Public Comment on 6279 Fernbank Development Applications and the

Fernbank Creek Catchment

Faith Blacquiere
Glen Cairn
21 Aug 2013

[DP/SD markup red = edge of marsh; green = adjacent properties impacted; yellow = topographic lines]

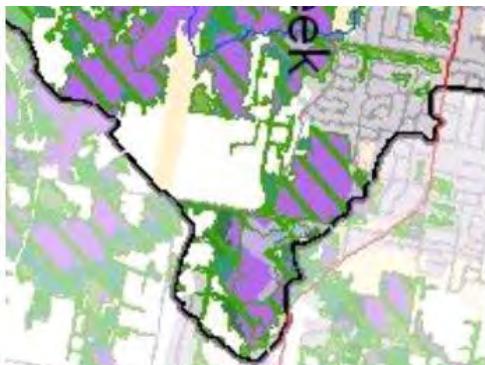
The first issue is the reconciliation of the topographic differences (shown on the title page) which should not have occurred if this developer had originally planned a Phase 3 for Cypress Gardens. The developer cannot change the drainage on the adjacent properties without agreement of every landowner, and should not be expecting adjacent landowners to pay for the drainage changes which are required to make the new development compatible with existing development.

On the Draft Plan of Subdivision (DP/SD), the rearyard topography overlaps property lines (see the DP/SD markup on the title page). If the developer had intended to build a Phase 3 development on the wetlands, one would have expected that the topography would have been designed to be more compatible with the addition of a 3d phase. If it is even topographically feasible to connect the new and adjacent properties, agreements with adjacent residents will be required to ensure that their drainage is not impacted. If the drainage mitigation is to provide rearyard swales, this will need to be added to the storm sewer capacity requirement. A potential alternative would be to provide a natural buffer between the properties, but even with this alternative, a drainage outlet may need to be provided.

No decisions on the DP/SD or the ZBA should be made until the analysis of the feasibility of reconciling the topography and drainage has been determined, and until agreements with all the adjacent landowners are in place. Subsurface bedrock contours and groundwater flows also need consideration.
